1st September 1885, No. 986, Revenue.

Taluk Cutcherry (2nd Class) at Manantoddy.

Plan Se on and Elevation
of the
Taluq Cutcherry at Manantoddy

Taluq Cutchery at Manantoddy

Scale 10 feet to an Inch

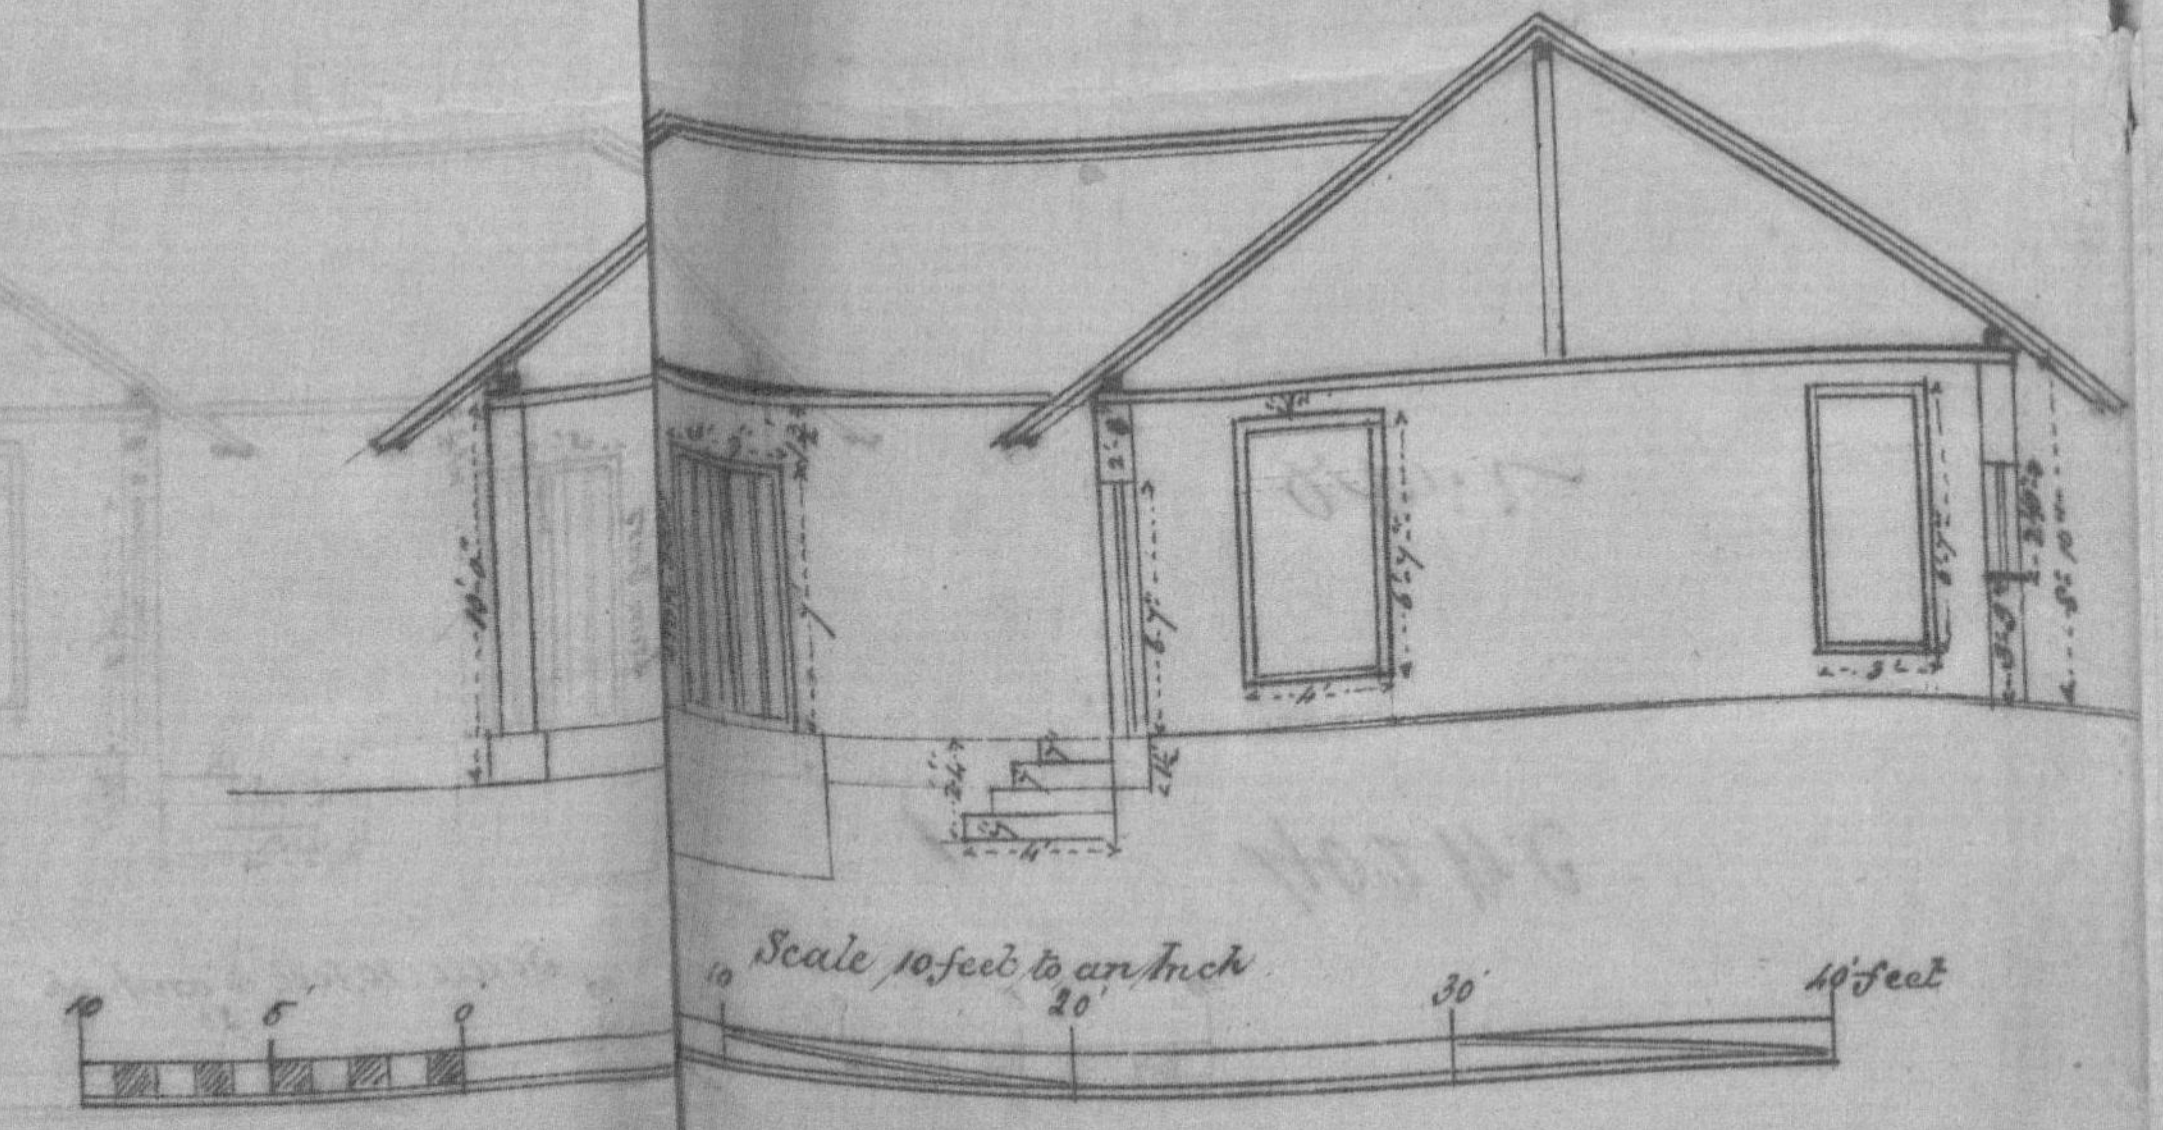
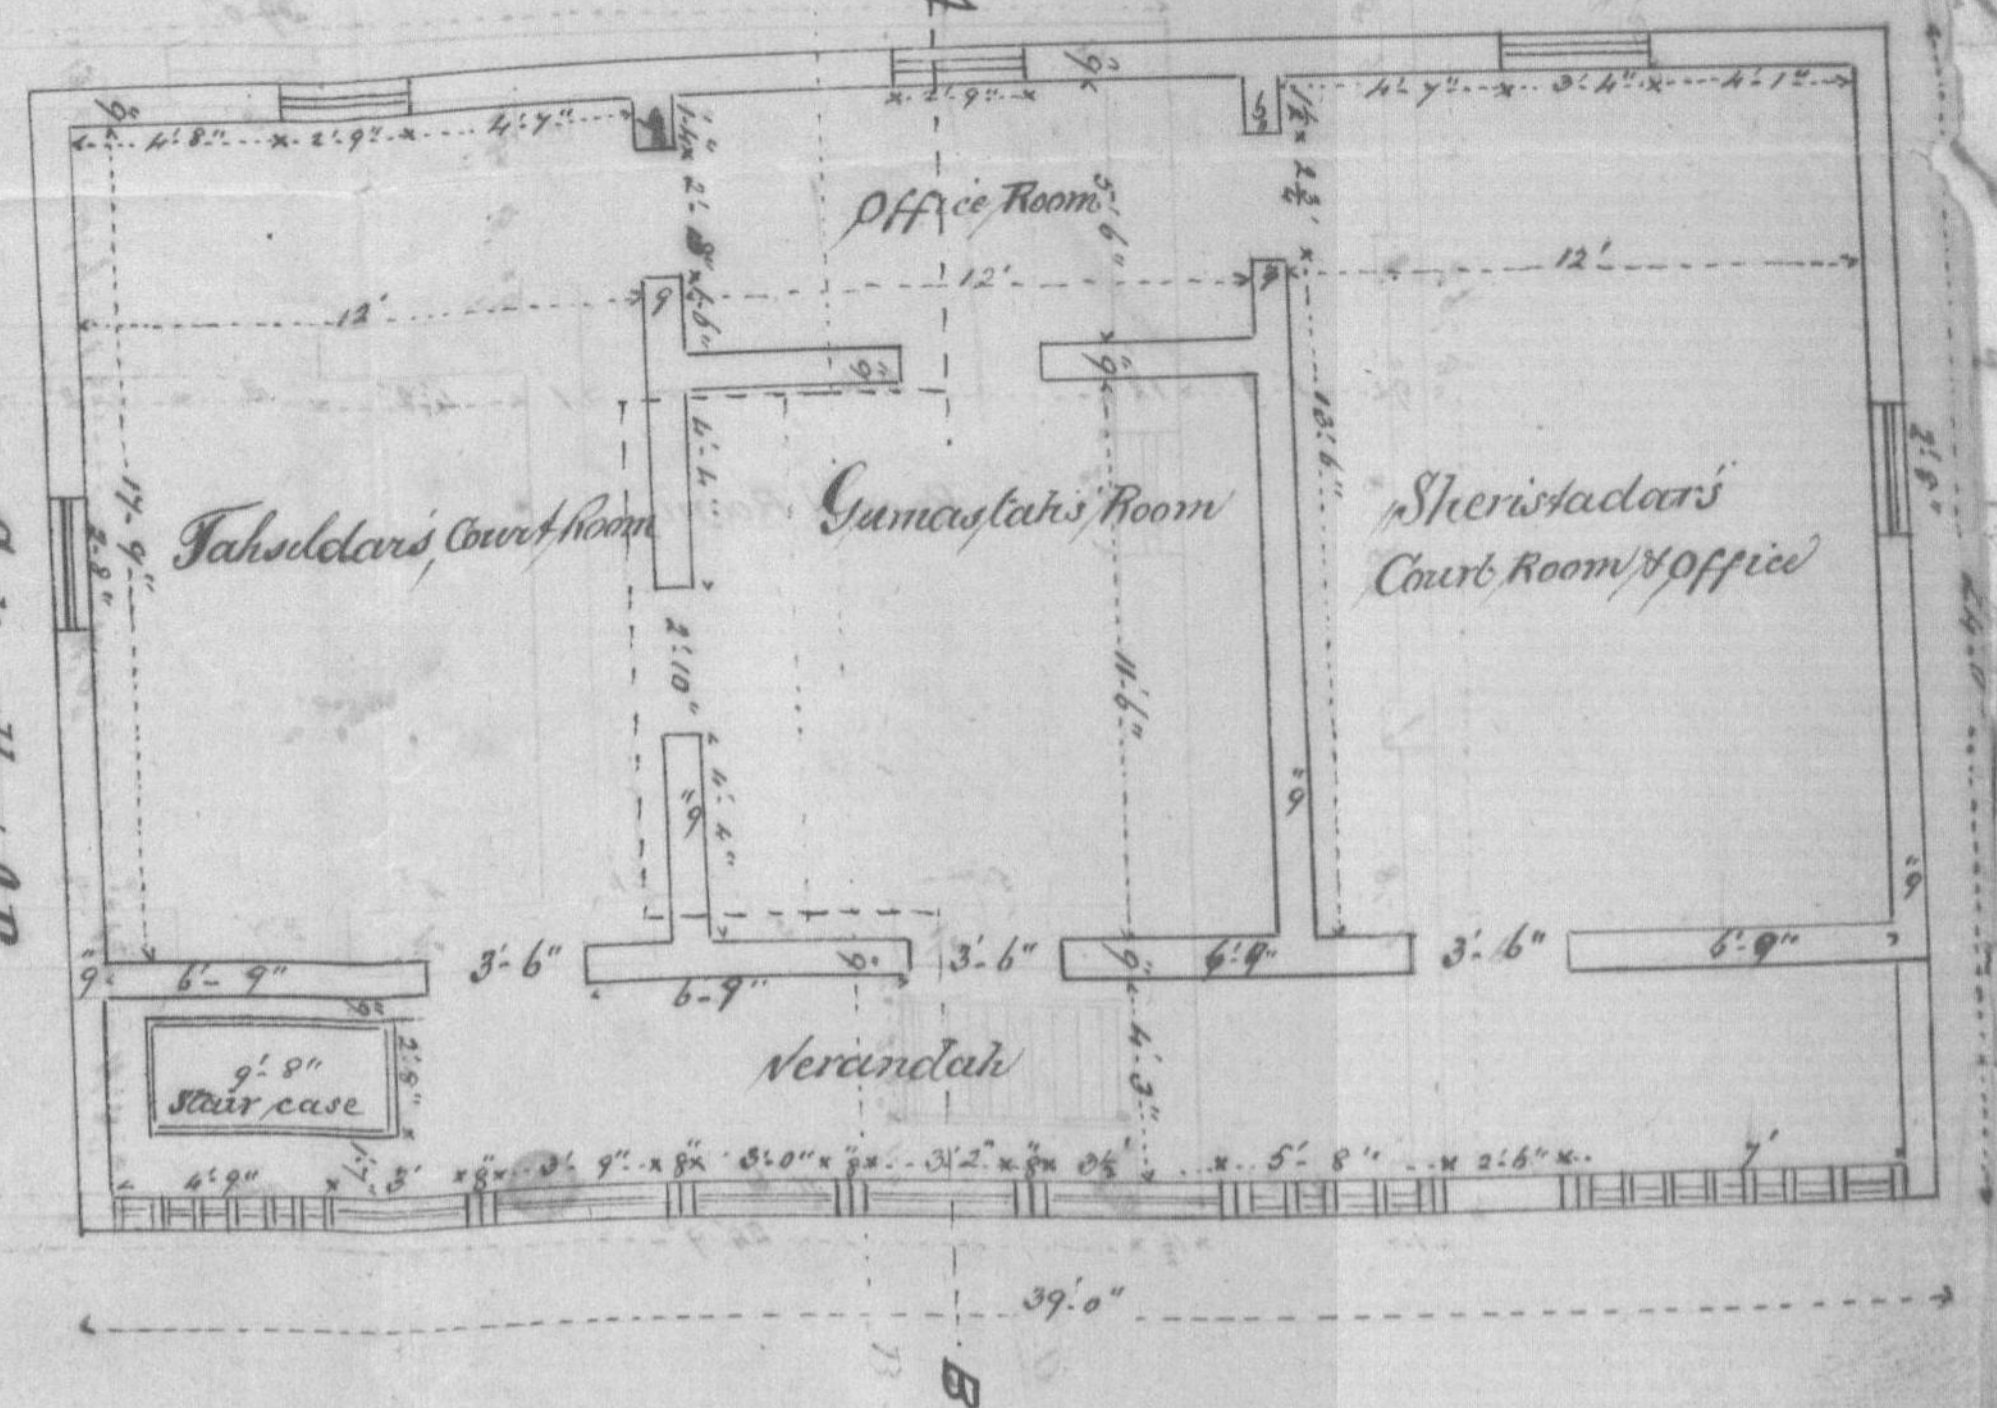
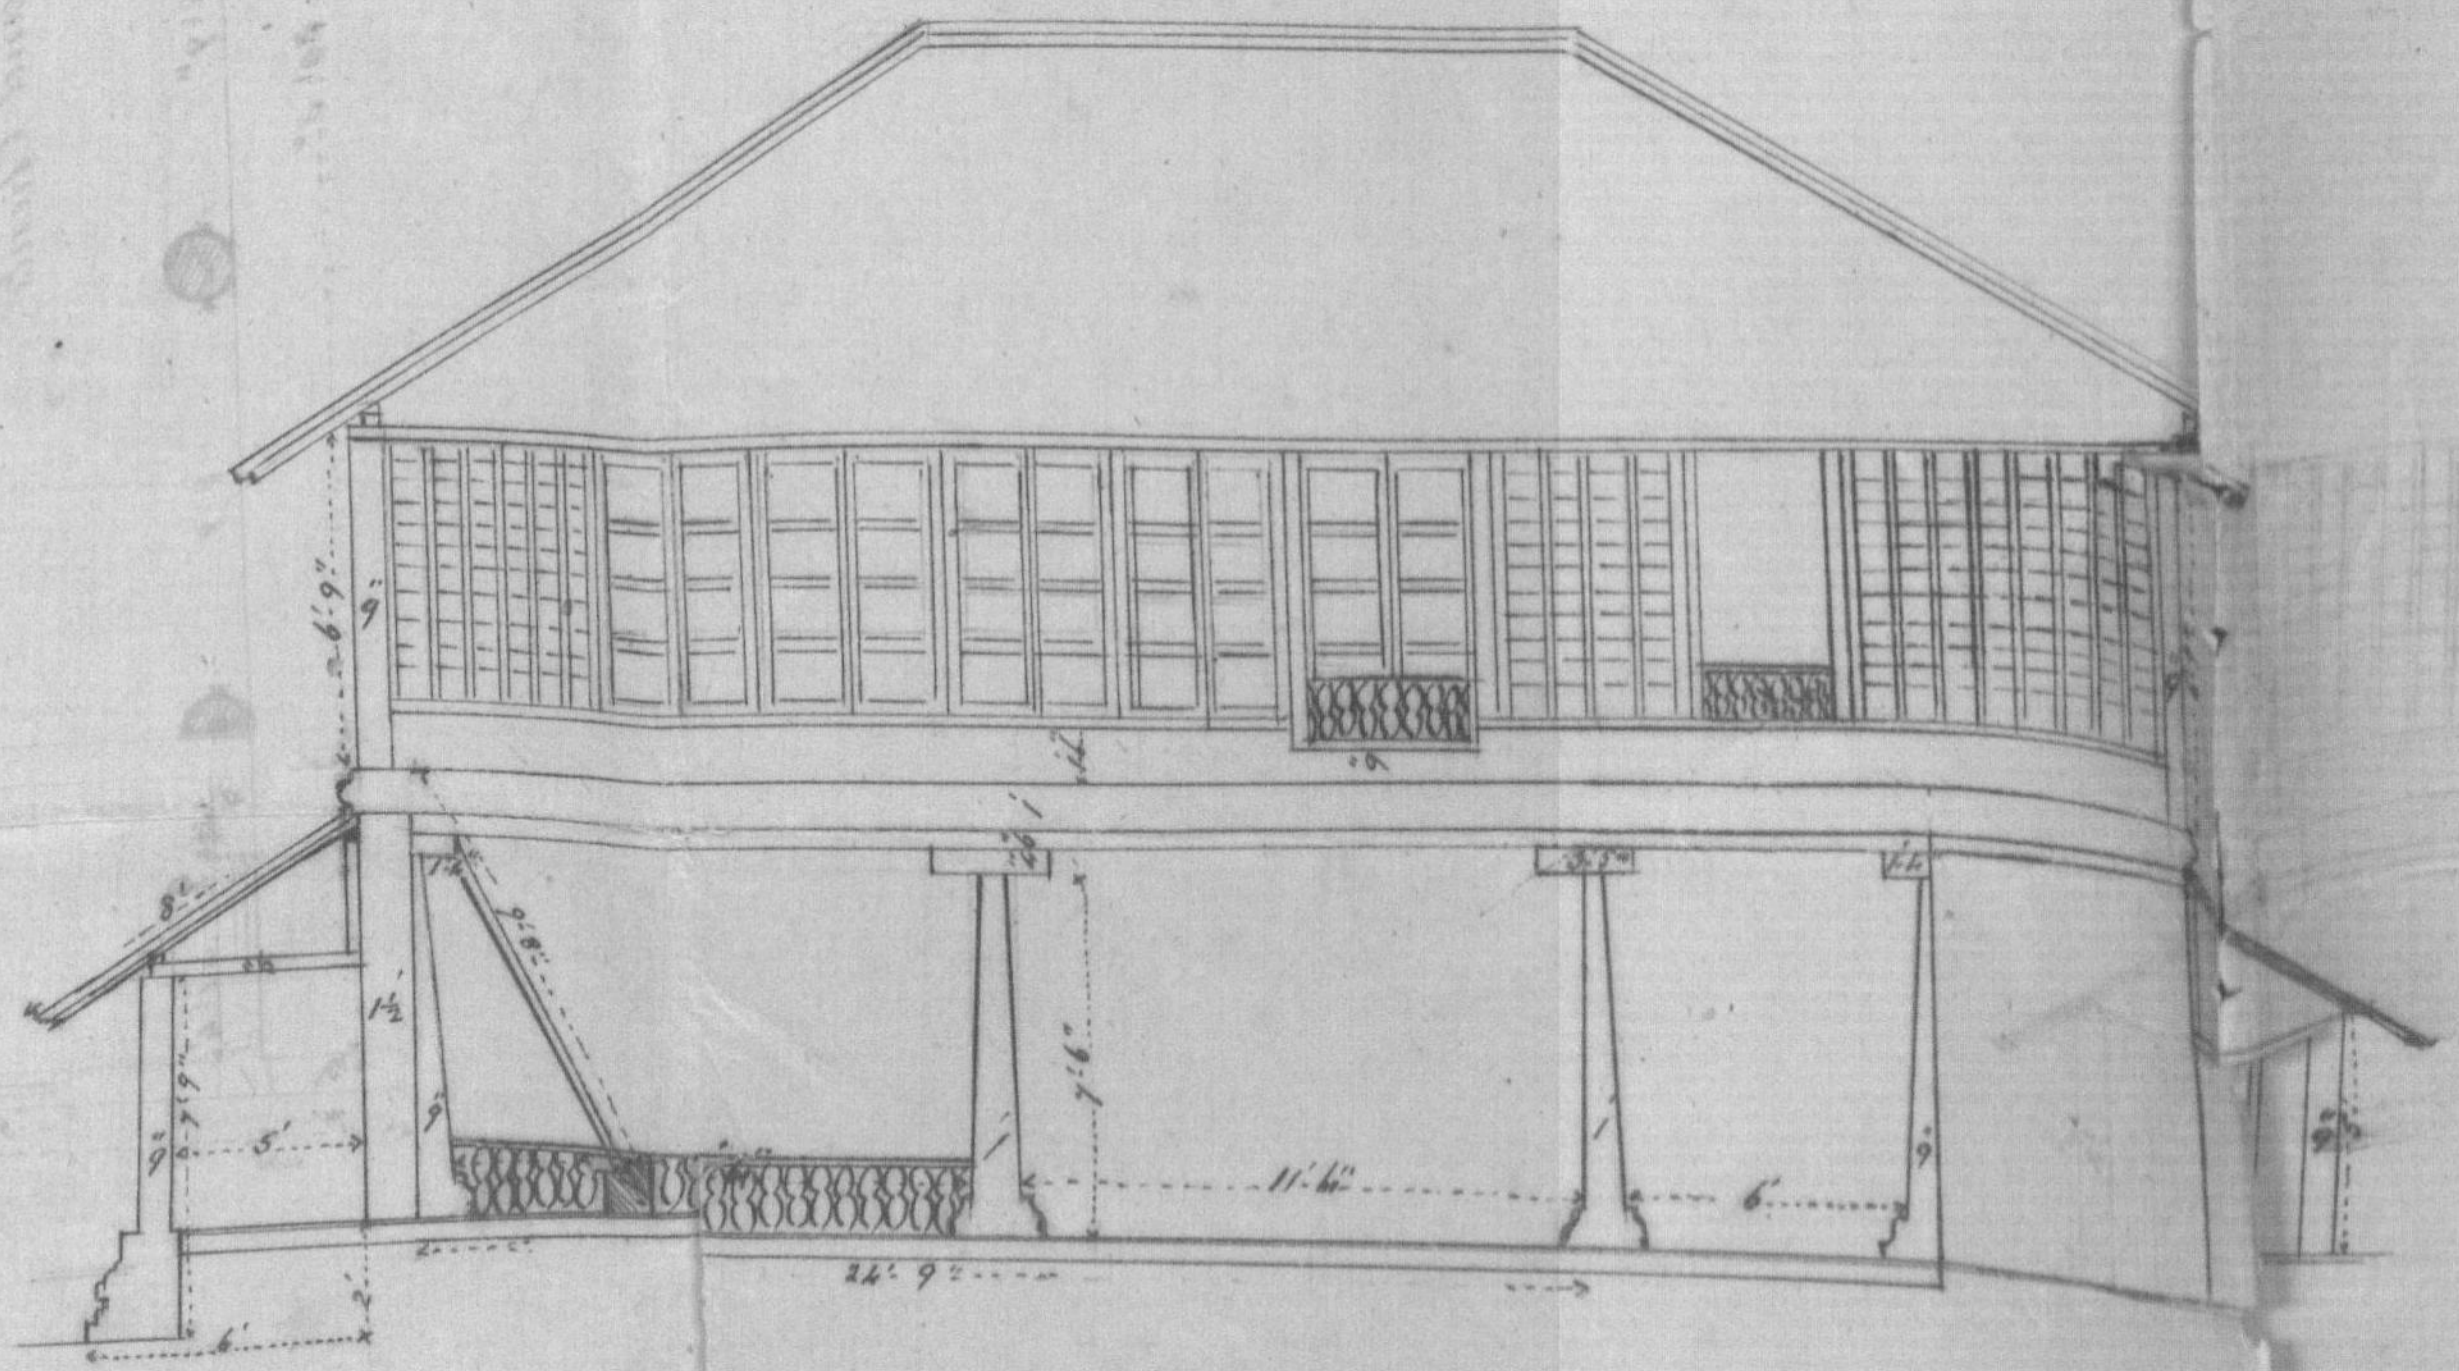
(4) The rooms are so low and ill-ventilated as to be sometimes almost stifling. Owing to the small size of the doors, even ordinary almirahs cannot be taken into them. The lighting is so bad that the clerks have to use lamps on cloudy days. Also owing to weakness of construction the whole building shakes in any strong wind;

(5) The treasury being in a detached building with no covered way between it and the main building, the Tahsildar and his establishment are subject to great inconvenience in rainy weather in passing to and fro between it and the main building;

(6) The treasury, sub-jail, and police station are very insecure, in a dilapidated shaky condition, and infested with rats and snakes. The walls are so weak that prisoners have escaped by breaking holes in them, and a mad prisoner kicked down one of them. The arrangement of the rooms is so bad that efficient guarding is impossible, and the treasury room is so dark that a lighted torch is required when entering it even on a bright summer's day.

(7) Finally, the buildings are stated to be in such a tottering condition that they will probably collapse, either entirely or in part, during the present monsoon.

3. From personal inspection I can certify that the Tahsildar has not in any way misrepresented the state of the building, and it will, I think, be manifest that it would be waste of money attempting to repair and improve it.

4. I request permission to submit plans and estimates for a new second-class cutcherry.
